# VALIDATION OPINION FOR REVISION OF REGISTERED MONITORING PLAN

**CECIC Gansu Yumen Changma No.3  
Wind Farm Project**

**UNFCCC Ref. No. 4734**

**SGS Climate Change Programme**

**Figure 1 Illustrative metering diagram**

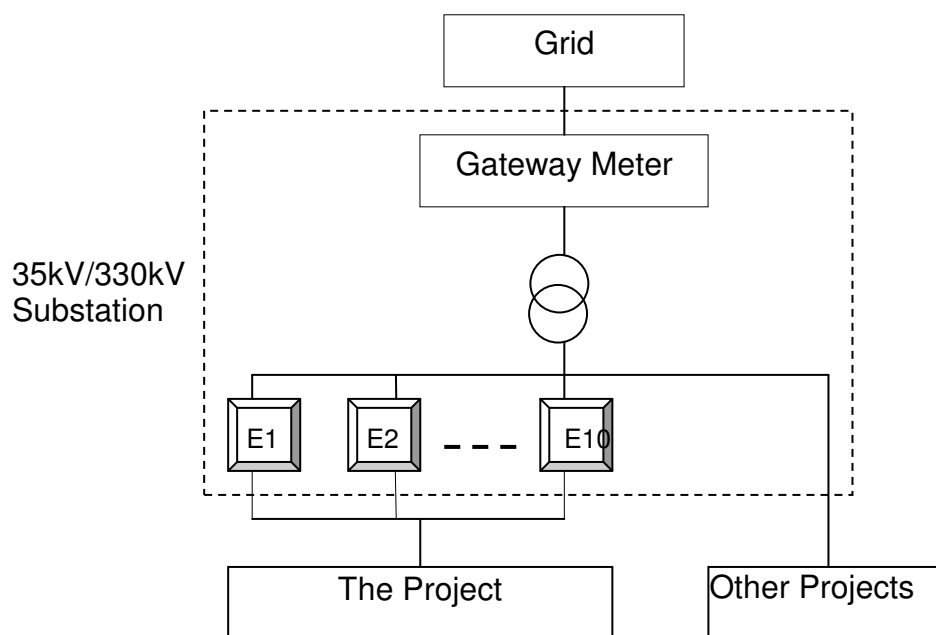
The line diagram of metering system in the proposed revision of monitoring plan is shown in Figure 1 below.

The electricity meters indicated in Figure 1 were installed during the project construction period and are all operated and maintained by the grid company. The electricity exported to the grid and imported from the grid by the Project are measured by meters E1 to E10. In accordance with the applied methodology, sales receipts will be used for cross check. Values to be settled on sales receipts are determined by the grid company based on the monitoring result of the gateway meter and meters of this project and meters of other project(s) sharing the gateway meter. The electricity exported to the grid and imported from the grid by other project(s) which share the same gateway meter with the Project can be measured by their own meters. The gateway meter can measure the total electricity exported to the grid and imported from the grid by all these projects. By reviewing the approach defined in the PPA agreed by the project company and grid company for issuing receipts of electricity sales, it can be confirmed that both values of electricity exported to the grid by the project and the electricity imported from the grid by the project used for settlement in sales receipts are issued monthly based on the meter readings of E1 to E10, gateway meter and the meters installed for other project(s) following pro-rata principle.

Considering the gateway meter is installed at the 330kV side of the 35kV/330kV substation, the measurement results from which do not include the transmission and line losses, the assessment team confirmed that the transmission and line losses have been taken into seriously account in the receipt of electricity sales issuing approach defined in PPA and this approach ensures the conservativeness of the values used for emission reductions calculation since only the conservative one from the two sources (values from meter readings of E1 to E10 and values from the receipts of electricity sales) will be adopted.

The meters of other project(s) and the gateway meter are not involved in the revised monitoring plan as parameters to be monitored due to the following reasons:

1. As stated above, the meters of other project(s) and the gateway meter are operated and maintained by the grid company which are out of the project company's control. Thus, it is not feasible to involve the above mentioned meters in the revised monitoring plan as parameters to be monitored.

2. The electricity exported to the grid by the project and the electricity imported from the grid by the project are directly measured by the meters E1 to E10. The meters of other project(s) and the gateway meter do not directly involve in the electricity measuring of the project. The measurement results from them are only used for issuing the receipts of electricity sales as per the approach defined in PPA. Furthermore, the values from the receipts of electricity sales are only used for cross checking purpose. Thus, as per the applied methodology, there is no need to involve the meters of other project(s) and the gateway meter in the monitoring plan as parameters to be monitored.

3. Although the meters of other project(s) and the gateway meter are out of the project company's control, the project company still can ensure the reasonability and reliability of the data obtained and used for Emission Reduction calculation. This is because besides the grid company, the project company can also read the meter readings of E1 to E10 through telecommunication system in the wind farm. Then, when the grid company inform the meter readings of E1 to E10 and final settlement electricity to the project company, the staff of project company can compare the values of final settlement electricity with the values from meter readings of E1 to E10 to see if the gap between the two sets of values are in a reasonable range considering the transmission and line losses.

Through document review, onsite visit performed by all team members and analysis above, the assessment team confirmed that it is reasonable and appropriate not to involve the meters of other project(s) and gateway meter as parameters in the proposed revision of monitoring plan. And the monitoring methods and procedures of Parameters  $EG_{facility,y}$  in the proposed revision of monitoring plan, including the monitoring meters and locations, monitoring and recording frequencies, are compliance with the applied monitoring methodology, i.e. ACM0002 version 12. The accuracy of the meters and the calibration frequency comply with Chinese nation standard, and are not reduced compared with the provisions in the monitoring plan of the registered PDD. The QA/QC procedures are also validated to be reliable and in line with actual monitoring of project by the assessment team. The statements of parameters in section B.7.1 and in item “Measurement meters” of section B.7.2 of the proposed revision of the monitoring plan are compliance with the actual monitoring system and the implementation of the project activity. Therefore, it is confirmed that the changes in the proposed revision of monitoring plan will not impact the accuracy and completeness of the monitoring plan in the registered PDD.
